Shearwater Petrel, Petrel 2, and Perdix Firmware v38 Release Notes

DocRev: A

Date: 2016-09-26

"OC/CC" mode renamed to "CC/BO" for clarity of purpose

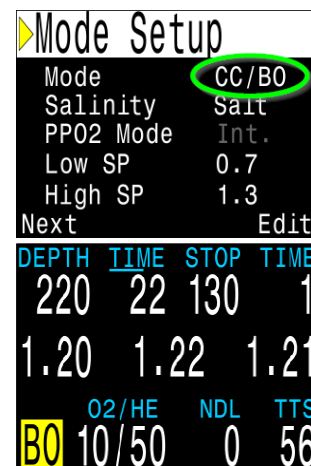
CHANGE: The 'OC/CC' mode has been renamed to 'CC/BO', where BO means bailout.

Purpose is to clarify that OC/CC mode was never intended to be used for purely OC dives. Using the OC/CC mode for OC dives results in sub-optimal operation. This change clarifies the CC/BO mode is for closed circuit dives, with open circuit bailout.

When diving OC, the mode should be set to either "OC Tec" or "OC Rec".

The tissues bar graph is now shown on the Tissues Restored screen

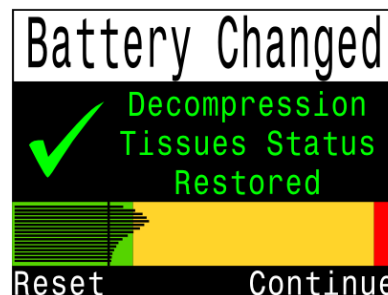
NEW FEATURE: After changing the battery, the current deco tissue loading is shown on the Tissues Restored screen.

NEW FEATURE: On the Tissues Restored screen, a shortcut to reset the tissues is given. If Reset is chosen, a prompt will be displayed to confirm.

The mark heading command now requires less button presses

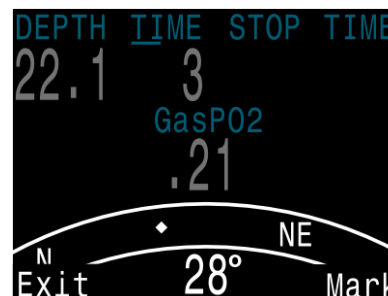
CHANGE: Compass mark heading menu moved to reduce button presses. Also, the compass can now be viewed while marking. Operation: when viewing compass a left button press brings up an “Exit Mark” menu. Right press marks compass, Left press exits to main screen. Previously had to navigate to regular

menus to mark the compass.

The offset between current and marked heading is now shown (in this example 16°)

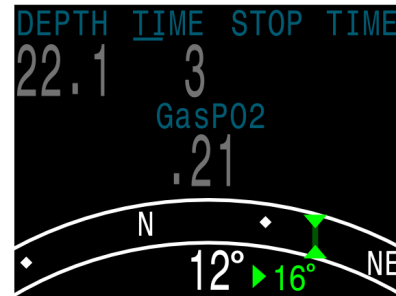
IMPROVEMENT: When a heading is marked, the display now shows the offset angle between the current heading and the marked heading. This is useful for navigating patterns. For example, a box pattern requires turns at 90° intervals, while a triangle pattern requires turns at 120° intervals.

On the "Bus Devices" page, choose "View" to see more info and settings

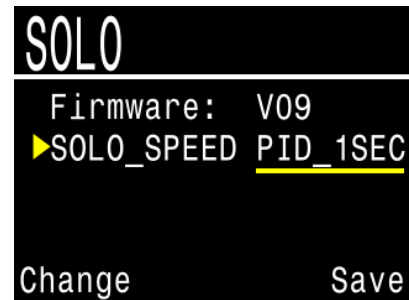
NEW FEATURE (DiveCAN Models Only): Added support for changing settings on peripheral boards.

For example, on the SOLO board (solenoid and oxygen controller) the Solenoid Speed setting can be adjusted. Go to "Bus Devices" page on Petrel to access peripheral boards. Settings viewed here are stored on the peripheral device.

If settings are available, they can be changed here. These settings are stored on the peripheral device.
